CACHUMA  
CONSERVATION  
RELEASE BOARD

May 31, 2011

Re: Comments on April 2011 2nd Revised Draft Environmental Impact Report for Consideration of Modifications to the United States Bureau of Reclamation's Water Right Permits 11308 and 11310 (Applications 11331 and 11332), State Clearinghouse No. 1999051051)

Prepared by Stetson Engineers, Inc.  
for the Cachuma Conservation Release Board

Figure 1. Combined frequency of scores 4 and 5 from RDEIR Tables 4-43-4-45.

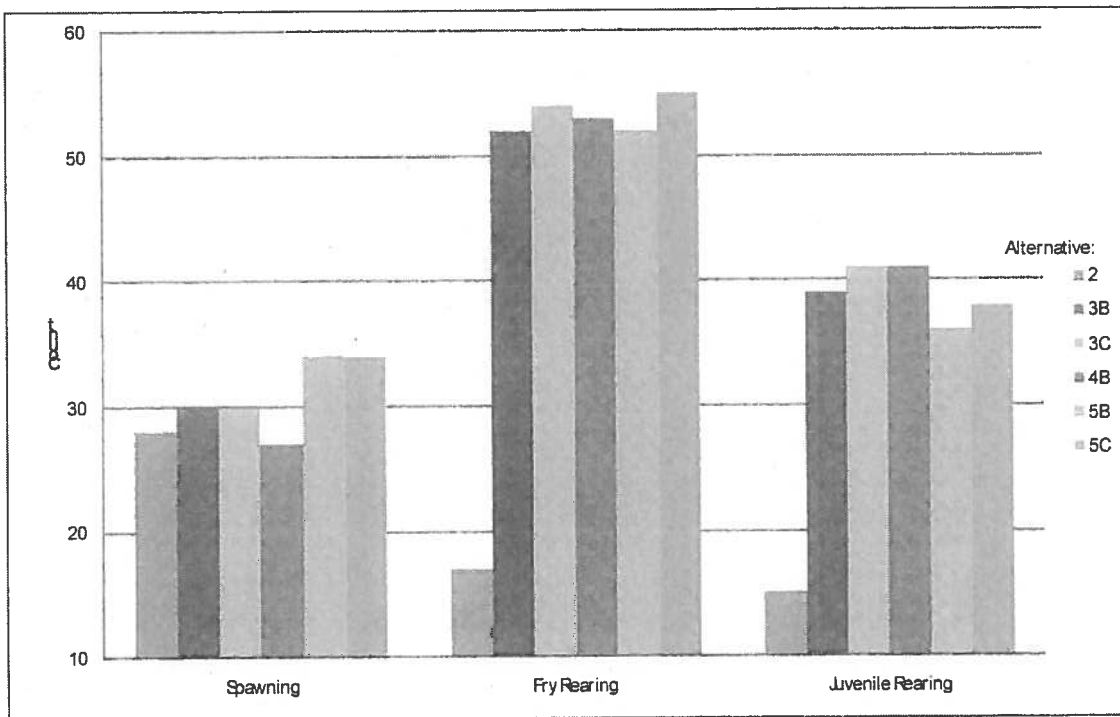
The analysis of the alternatives on steelhead spawning and rearing in the Lower Santa Ynez River is divided into three separate analyses summarized in Tables 4-43 – 4-45 (RDEIR pages 4.7-46 – 4.49; see also Figure 1 below). The separate analyses conclude that all four alternatives result in a beneficial effect on steelhead spawning and rearing compared to baseline operations with “Alternatives 5B and 5C showing the most benefits to rearing” (page 4.7-49, paragraph 4). We disagree with this statement in that in our estimation this analysis should integrate all lifestages and habitat relationships of steelhead/rainbow trout in the Lower Santa Ynez River and account for habitat bottlenecks when evaluating the alternatives.

CCRB agrees with the analysis that all alternatives result in a beneficial effect on steelhead/rainbow trout spawning over baseline conditions. We note that the differences in habitat improvement for spawning between Alternatives 5B and 5C and Alternatives 3B and 3C are insignificant. Examination of Table 4-43 reveals that Alternatives 5B and 5C are superior to Alternatives 3B and 3C (based on the scoring criteria) in only 6 percent of the years. This improvement, however, is offset by an increased frequency of years receiving a score of 1 (2.6 percent of years as compared with Alternatives 3B/3C). Increasing the frequency of years with poor habitat is likely to have a greater impact to steelhead/rainbow trout spawning and survival than increasing the number of years with scores of 4 to 5. The analysis does not consider the greater impact to the population at the lower end of the scale in evaluating the scores.

In examining the impacts to rearing habitat, the analysis should account for habitat bottlenecks which, in the Santa Ynez River, occur during the juvenile lifestage. While Alternative 5C shows

a slight advantage over Alternatives 3B, 3C, 4B and 5B for fry rearing (RDEIR Table 4-44; Figure 1 below), Alternatives 3B, 3C and 4B have an advantage over Alternatives 5B and 5C for juvenile rearing (RDEIR Table 4-45; Figure 1 below). Habitat bottlenecks during the juvenile lifestage affect later life stages, i.e., the adult steelhead population size. This would eliminate any minor advantage that could accrue for steelhead during the spawning or fry stage. Steelhead fry produced during the spring grow into juvenile fish and continue to reside in the River through the fall and into the winter when habitat is limited. Thus, any additional fry produced under Alternatives 5B or 5C must pass through a habitat bottleneck occurring during the juvenile rearing stage. Alternatives 3B and 3C and Alternatives 5B and 5C provide similar flows in fall and winter. Therefore, in view of the potential limitations to juvenile rearing in the lower Santa Ynez River, Alternative 5B or 5C would not be expected to increase production relative to Alternative 3B or 3C, since the same habitat limitation would apply at the juvenile rearing stage. These considerations indicate that it is unlikely that Alternatives 5B and 5C will provide any additional benefit to steelhead/rainbow trout over Alternatives 3B and 3C.
